CITY OF CARMEL-BY-THE-SEA HISTORIC RESOURCES BOARD AGENDA

- 3) **DS 25240 (Ramos):** Consideration of a Determination of Consistency with the Secretary of the Interior's Standards for Design Study application, DS 25240 (Ramos), for after-the-fact revisions to a previous

TO: Historic Resources Board Members
SUBMITTED BY: Katherine Wallace, Associate Planner
SUBJECT: **DS 25240 (Ramos):** Consideration of a Determination of Consistency with the Secretary of the Interior's Standards for Design Study application, DS 25240 (Ramos), for after-the-fact revisions to a previous approval (DS 23396) that include the removal of roof shingles, horizontal wood siding, wood shingle siding, wood windows, and a Carmel stone chimney, replaced with new at the historic "Rockwell House" located on the northeast corner of San Antonio and 12th Avenues in the Single-Family Residential (R-1) Zoning District and the Beach and Riparian Overlay District. APN 010-279-008-000

PROPOSED ELEVATION

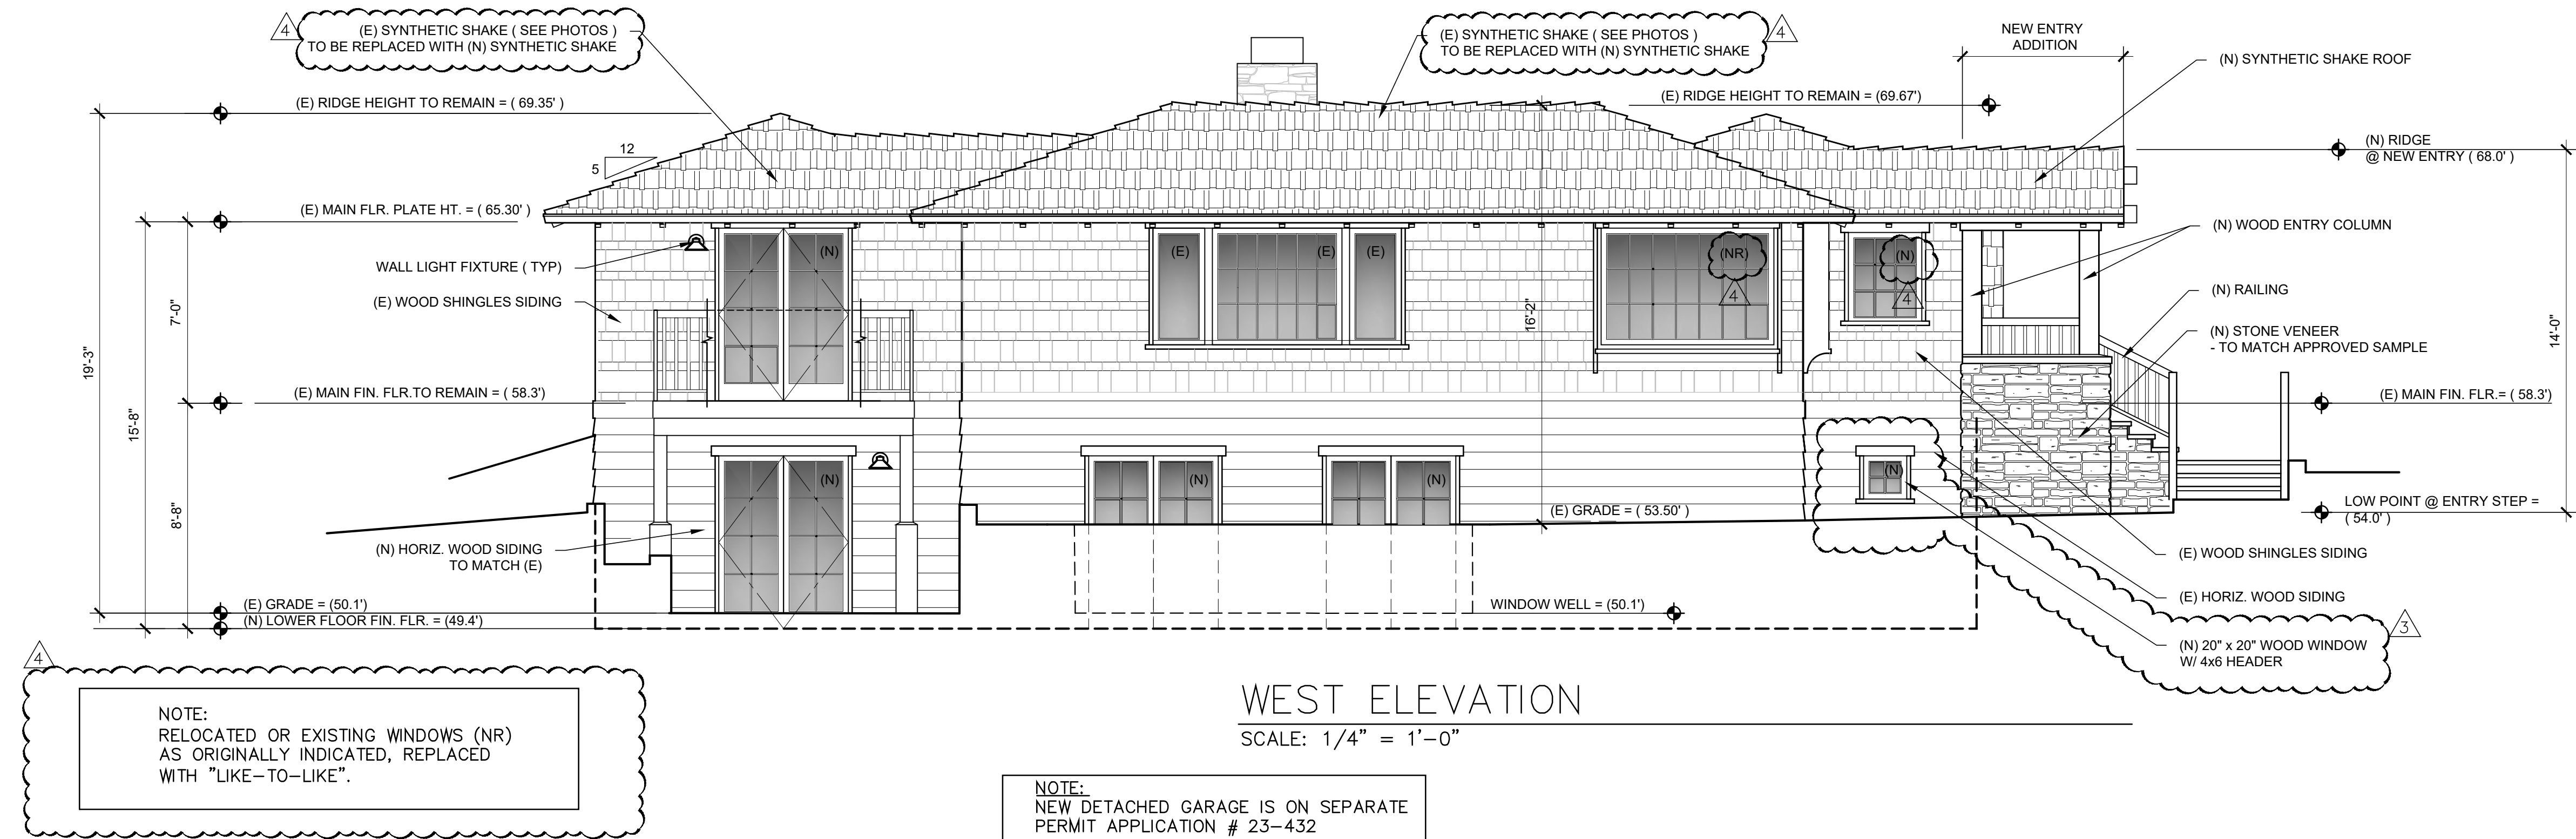
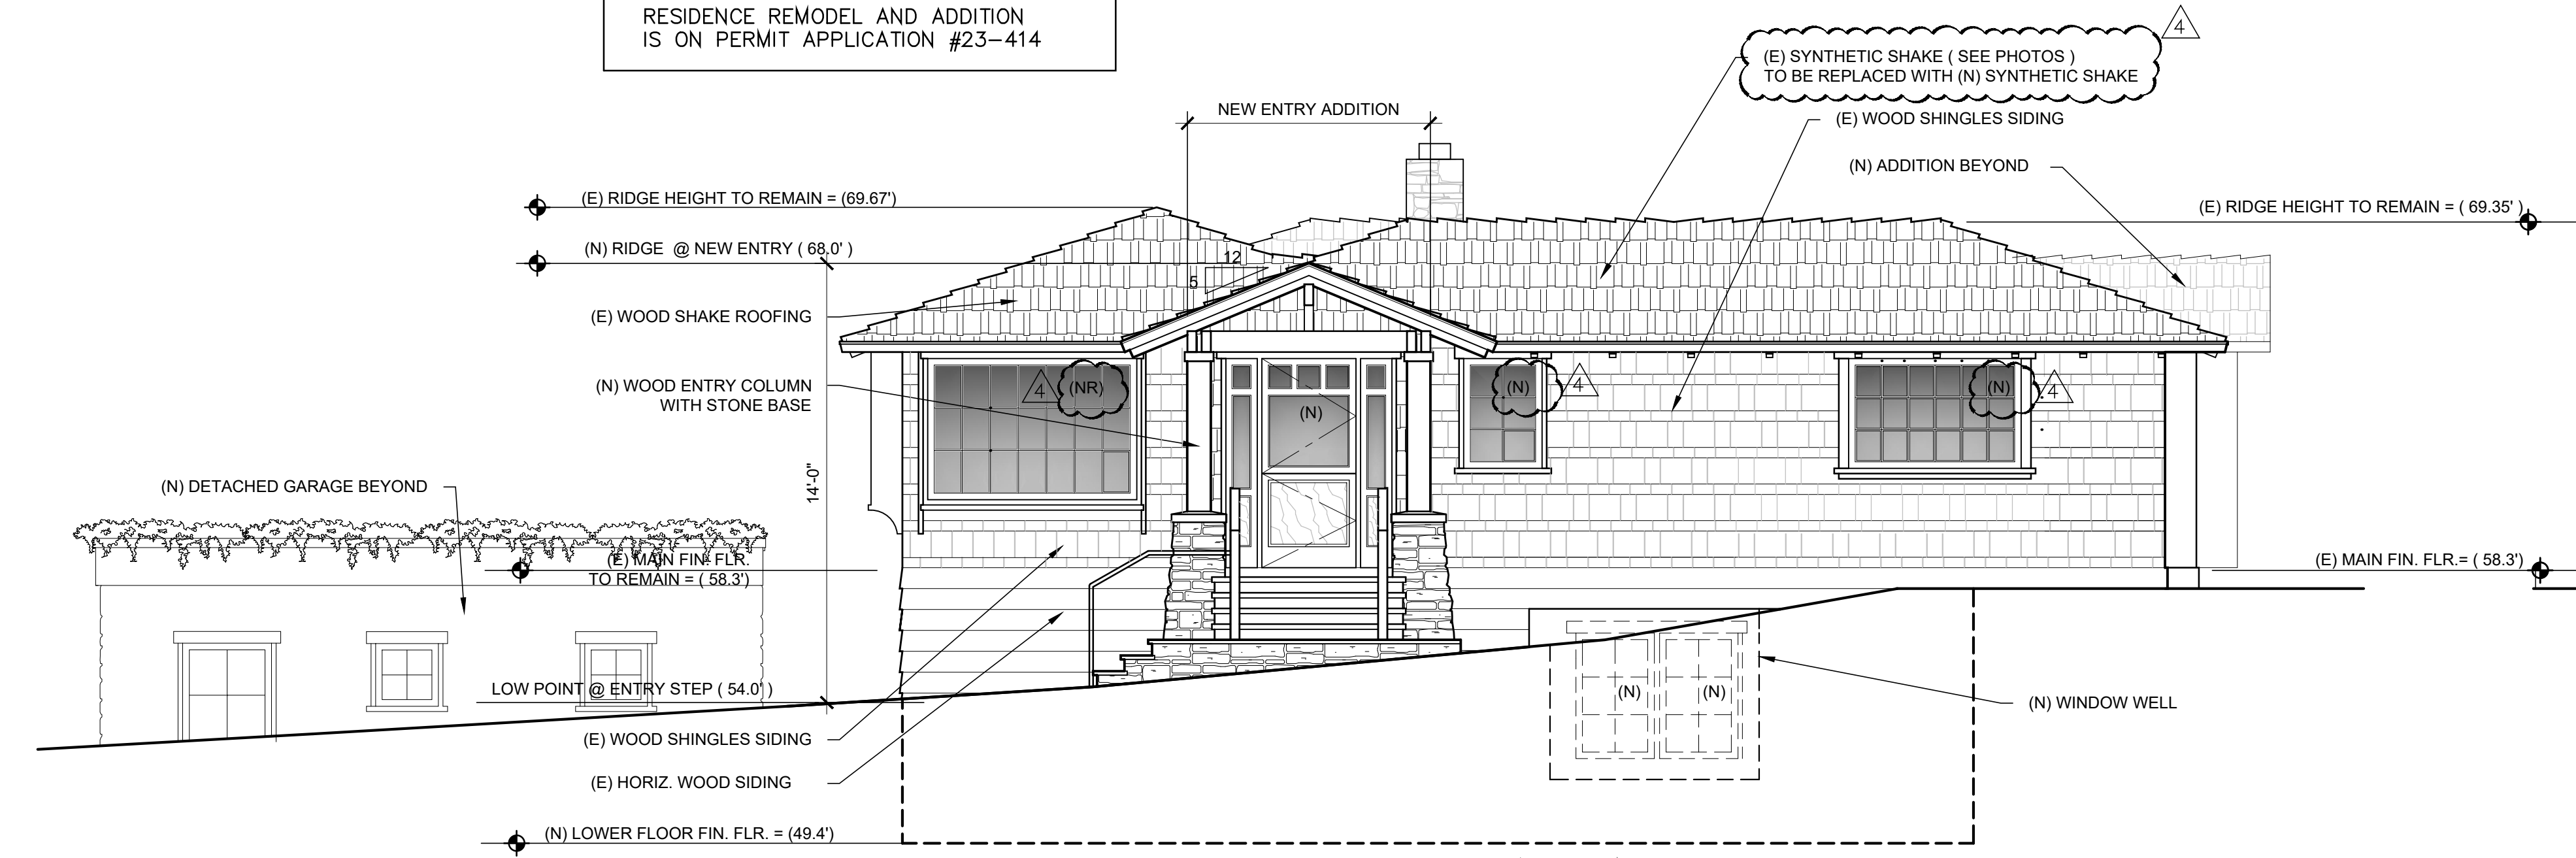
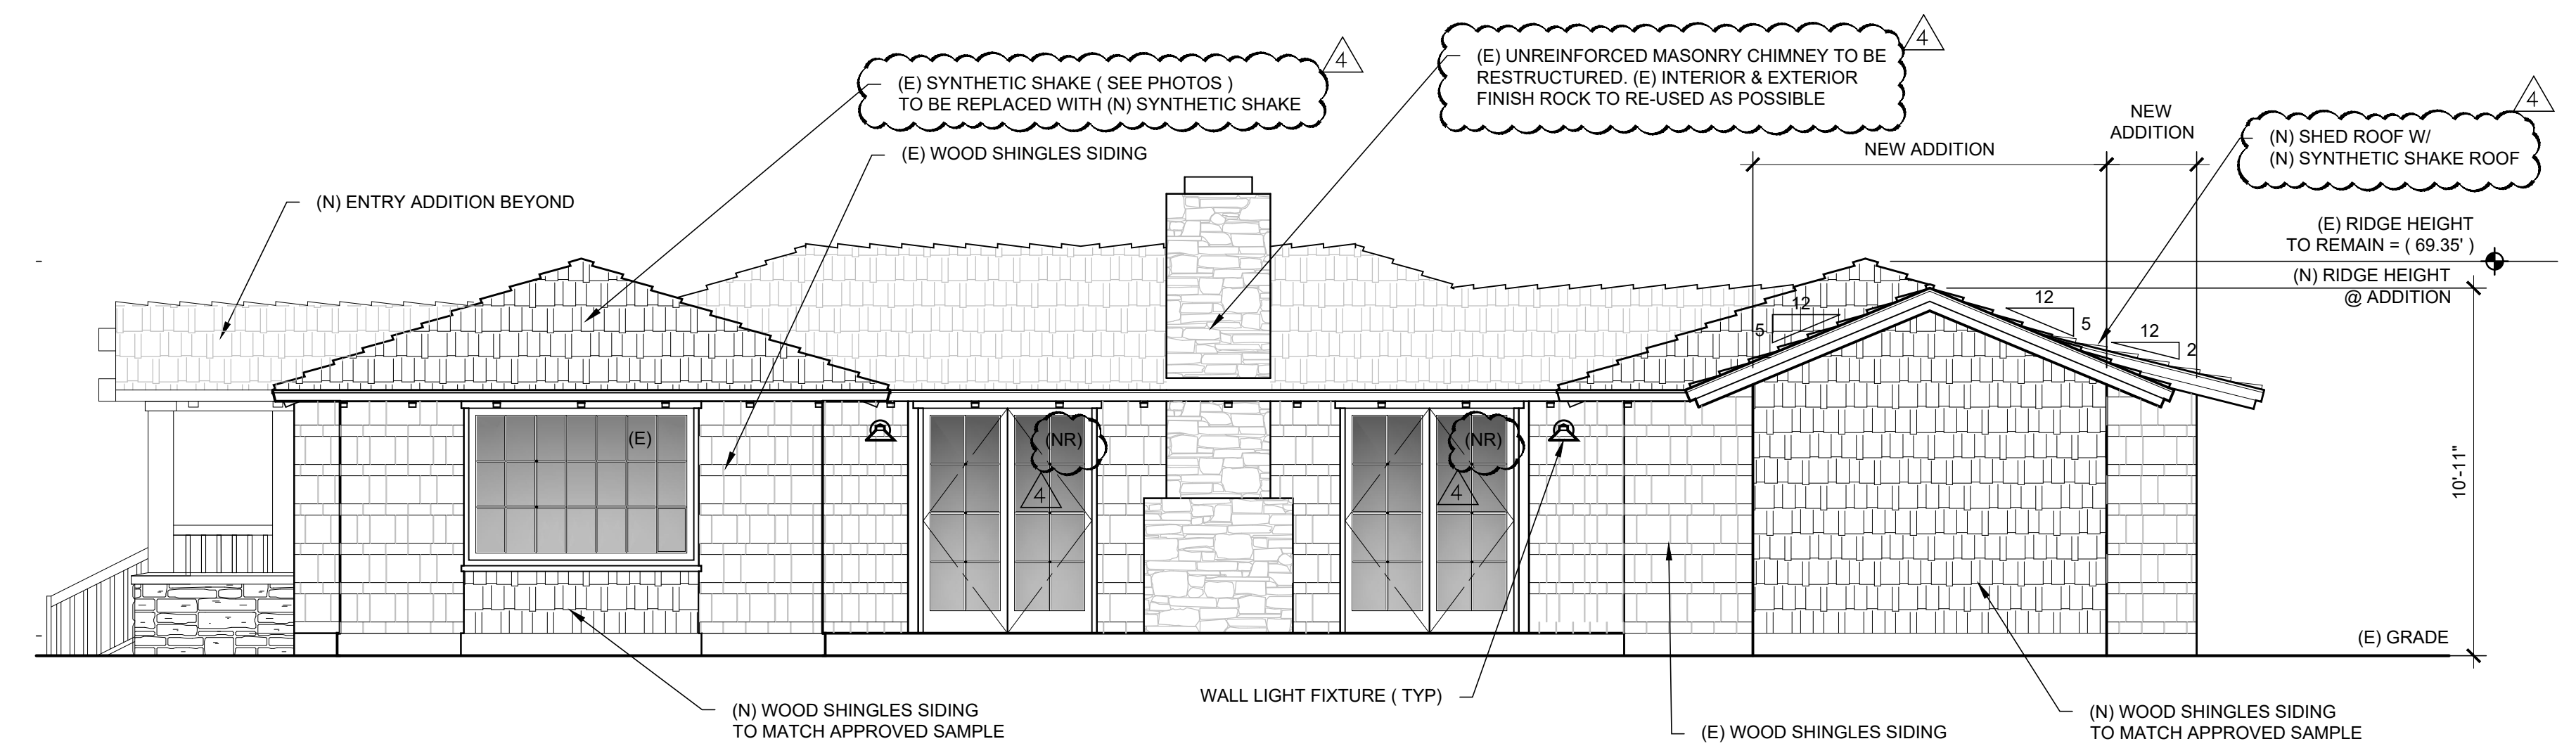
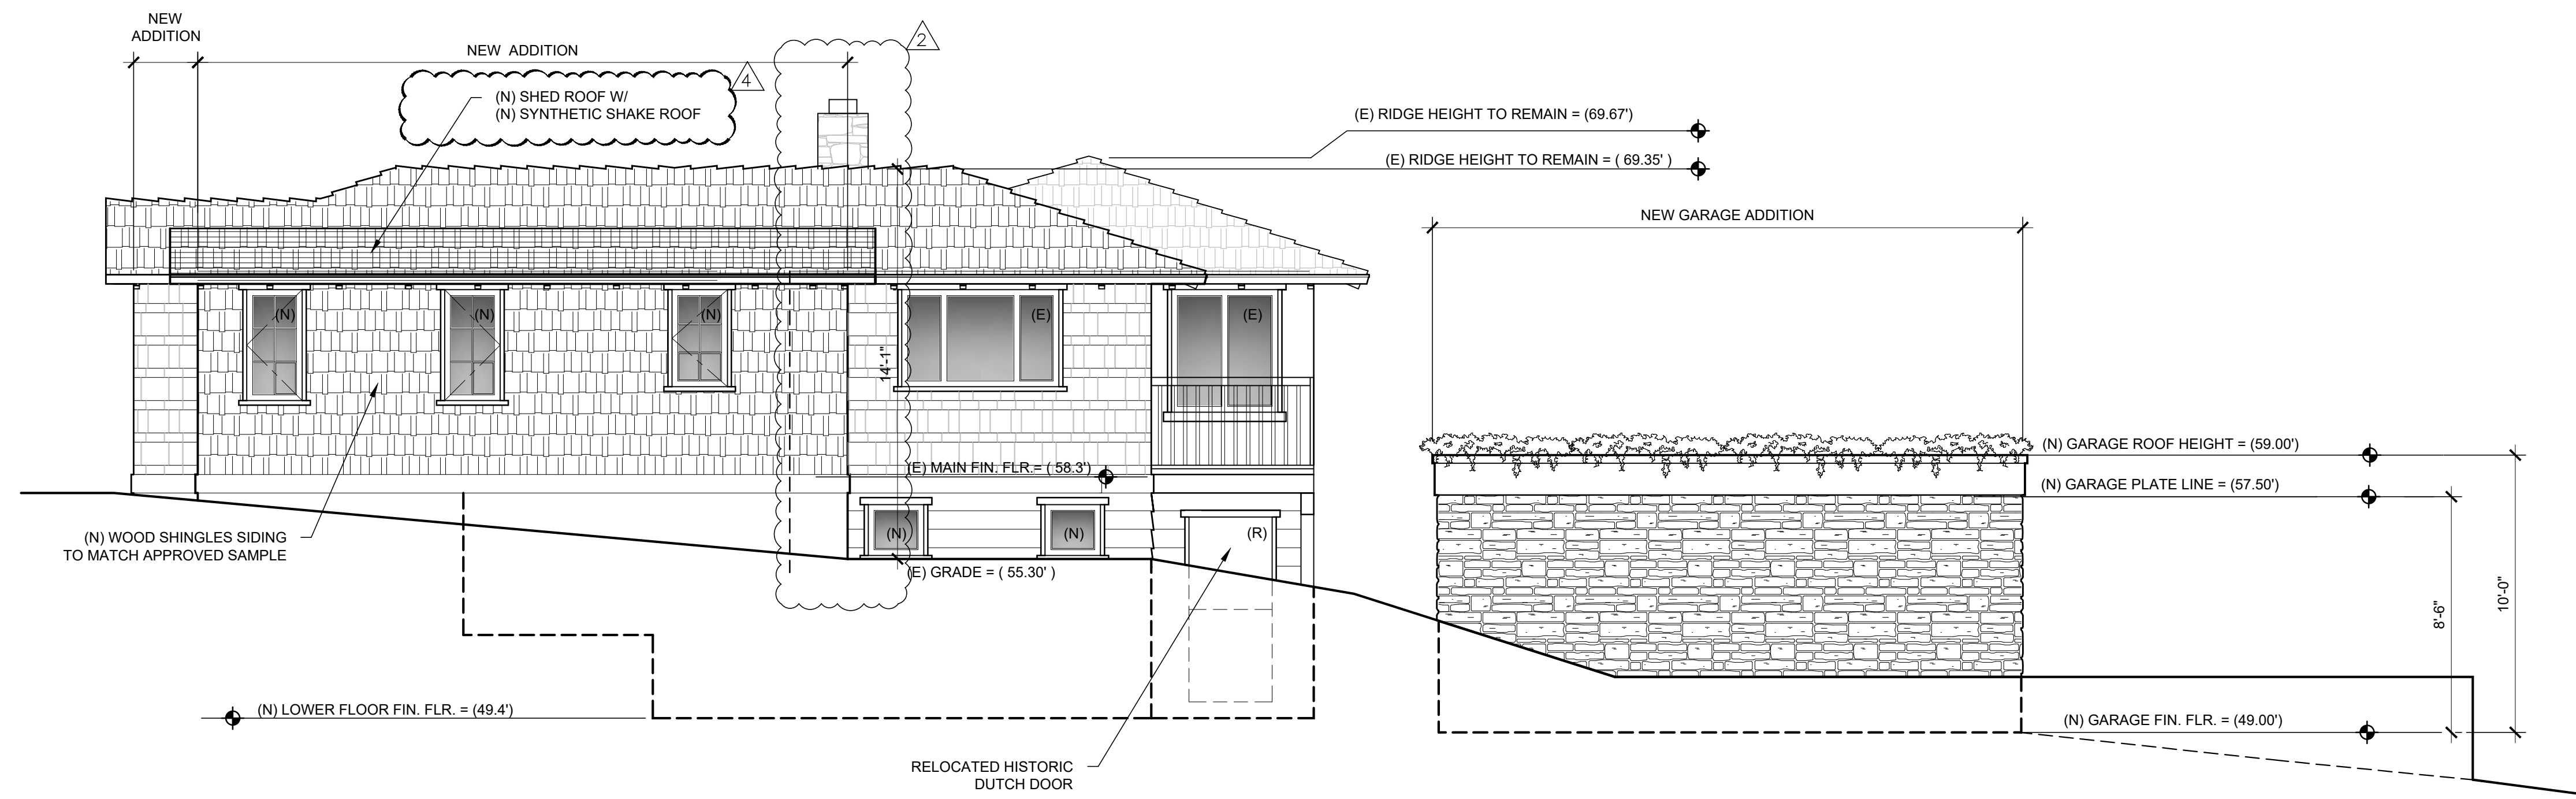
To be consistent with Standard Nine, any new siding used in the additions should be differentiated from the existing siding, so the additions are clearly discernable from the historic house. However, the shingles on the additions currently match the original "ribbon course" pattern used in the historic house (see Figure 6).³ To differentiate the shingles on the additions, the architect and contractor have suggested removing 5/8" from selected shingles along the shingle course in the additions to create a staggered pattern (see Plan Sheet A3.1). This solution will differentiate the old from the new materials and meet the requirements of Standard Nine.

Based on the recommendations of the qualified professional, Margaret Clovis, the after-the-fact project components are consistent with the Secretary of the Interior's Standards for the Treatment of Historic Properties, except for the new chimney and the non-differentiated wood shingles on the additions. As such, staff recommends the Board incorporate condition of approvals as part of the determination. The conditions shall require that prior to approval of the Design Study (DS 25240), the owner/applicant shall submit modified plans to staff that demonstrate:
